91-18-4 CONVERTIBLE TOP: RIP STOP SHIELD INSTALLATION

1991 Mercury Capri

TECHNICAL SERVICE BULLETIN

CONVERTIBLE TOP - TEARS AT TOP OF "B" PILLAR

Fig. 1: Location of Convertible Top Tear

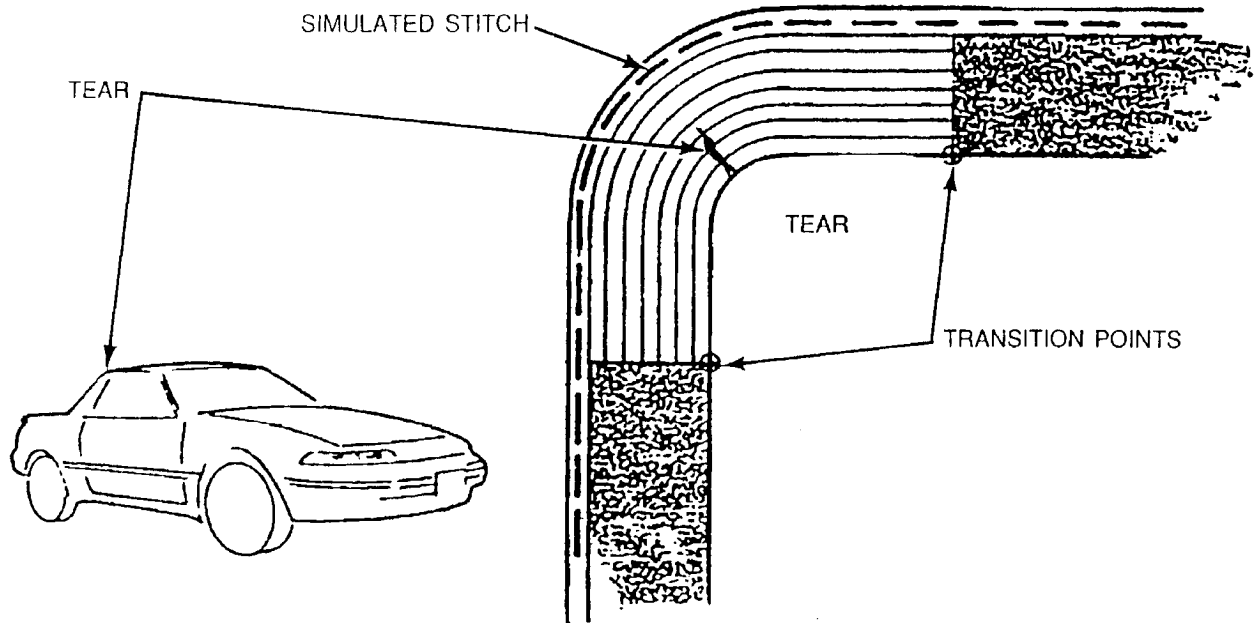
ISSUE: The convertible top fabric may catch behind the shingle weatherstrip when raising the top, causing a tear at the top of the "B" pillar. See Fig. 1.

ACTION: Install a rip stop shield. Refer to the following procedure for service details.
